Request for Quotation

RFQ NUMBER
7011EC15

NINE CUBIC YARD 304 STAINLESS STEEL
DEMOUNTABLE ABRASIVE AND CHEMICAL SPREADER (HYDRAULIC)

PREBID ADDENDUM #1
7011EC159 CUBIC YARD STAINLESS STEEL
DEMOUNTABLE ABRASIVE AND CHEMICAL SPREADER (HYDRAULIC)

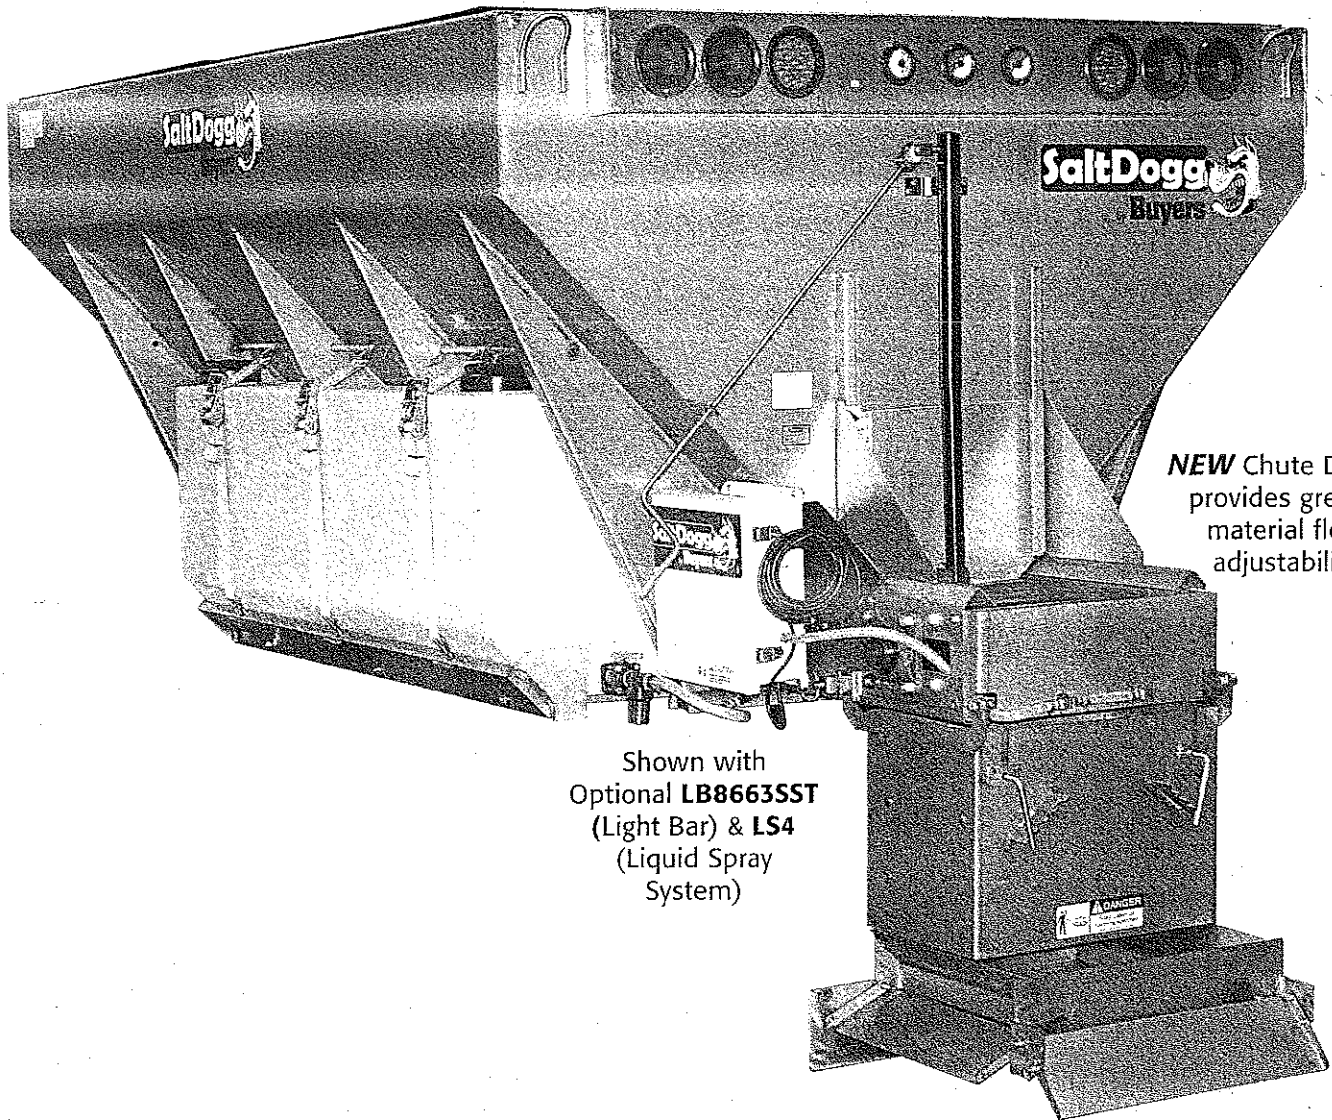
9. Is a 6.3 cubic yard capacity acceptable for RFQ14?
RESPONSE: No
11. The lighting drawing shows lights combined in housings but previous spreaders have been supplied with individual weatherproof housing as per the picture below. Are the individual weatherproof housings still allowed?

RESPONSE: As long as you still are in compliance with the spec.
